# HEALTHCARE INTERPRETATIONS TASK FORCE

## AGENDA

JUNE 14, 2011

## INTERPRETATION REQUESTS JUNE 2011

### ITEM A-5 – ALCOHOL HAND RUB

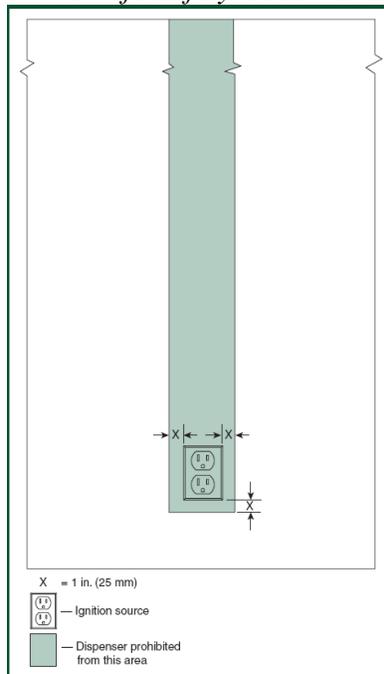
The 2000 Life Safety Code TIA and 2006 Code allowed for AHJ judgment/interpretation concerning proximity to ignition sources. Section 19.3.2.6 (6) states, “*The dispensers shall not be installed over or directly adjacent to an ignition source.*” In 2006 The Joint Commission published information defining “adjacent to” as no closer than 6 inches, center of the dispenser to either side of the ignition source. Currently, according to TJC SIG and surveyors in the field, the interpretation enforced is 6 inches from center of the dispenser to center of the ignition source.

Especially considering that some AHJs have adopted the 2009 Life Safety Code, it seems counterproductive and confusing for TJC and possibly CMS to be surveying for “adjacent” (the 6 inch interpretation) when NFPA has more recently precisely defined dispenser and ignition source criteria. The 6 inch from center interpretation can be more stringent than the 2009 Code 1-inch criterion, resulting in the need to move multiple dispensers slightly further away when they complied with 2009 Code.

Is it the intent of The Joint Commission 2000 Code interpretation to be more stringent than the 2009 Code precise criterion?

Concerning placement of Alcohol-Based Hand-Rub Dispensers, where the 2000 Life Safety Code TIA 00-1 or the 2006 Life Safety Code is applicable, are the criteria specified in 19.3.2.6 (7) of the 2009 Life Safety Code acceptable?
